CASE COMMENT REPORT

CASE NO. UDP-S24054

CASE:	UDP-S24054
MEETING DATE:	September 24, 2024
REQUEST:	Site Plan Level II Review - Change of Use from Residential Use to 1,412 Square Feet of Medical Office Use
APPLICANT:	HUB & Spoke, LLC.
AGENT:	Carlos Pizarro
PROJECT NAME:	Azala Skin Clinic
PROPERTY ADDRESS:	412 SE 13th Street
ZONING DISTRICT:	Residential Office (RO)
LAND USE:	South Regional Activity Center
COMMISSION DISTRICT:	4 - Warren Sturman
NEIGHBORHOOD ASSOCIATION:	Poinciana Park Civic Association
CASE PLANNER:	Nancy Garcia

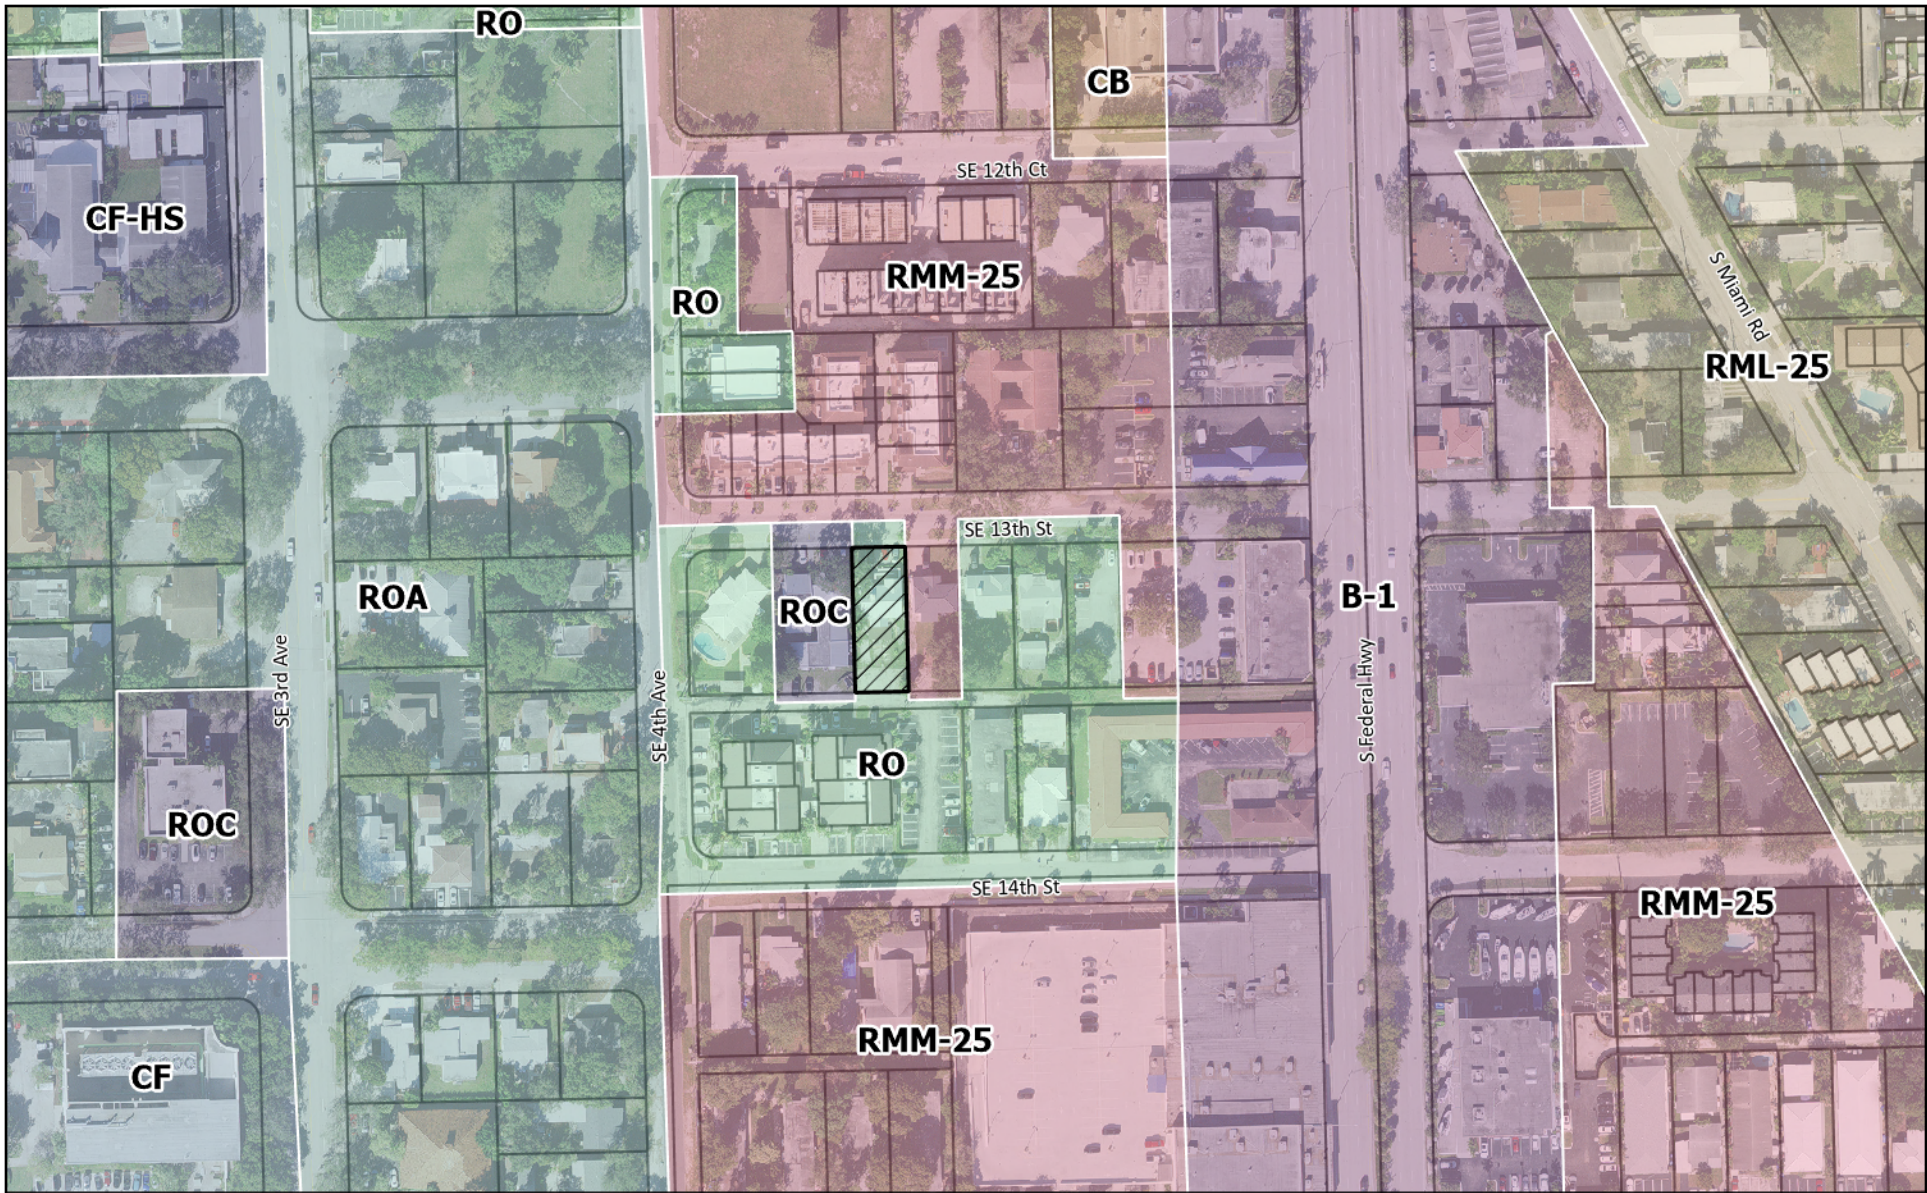
5. Provide the following changes on site plan:
 - a. Brick decorative pavers or similar paving material covering 100% of the parking surface shall be installed for the parking spaces proposed on the southern side of the site, near the alley.

- b. Show location of refuse container. All solid waste refuse containers (dumpsters) shall be set back a minimum of 12 feet from any property line which is contiguous to residential property and shall be screened in accordance with the Dumpster requirements, as provided in Section 47-19, Accessory Uses, Buildings and Structures.

- c. A ten (10) foot landscape strip shall be required to be located along all property lines which are adjacent to residential property. Such landscape strip shall include trees, shrubs and ground cover as provided in the landscape provisions of Section 47-21, Landscape and Tree Preservation Requirements. The width of the landscape area shall extend to the property line. All required landscaping shall be protected from vehicular encroachment. When walls are required on nonresidential property abutting an alley, required shrubbery shall be installed and located within the landscape area on the exterior of the wall

- d. Provide height of the existing opaque fences that are to remain and proposed landscaping adjacent to the residential properties. A wall shall be required on the nonresidential property, a minimum of five (5) feet in height, constructed in accordance with Section 47-19.5, however, in instances where installation of the wall would require a modification of the existing vehicular use area, which would impair traffic circulation on the site, a minimum five (5) foot high hedge, fence or other physical barrier shall be placed along the length of the nonresidential property line which abuts the residential property.
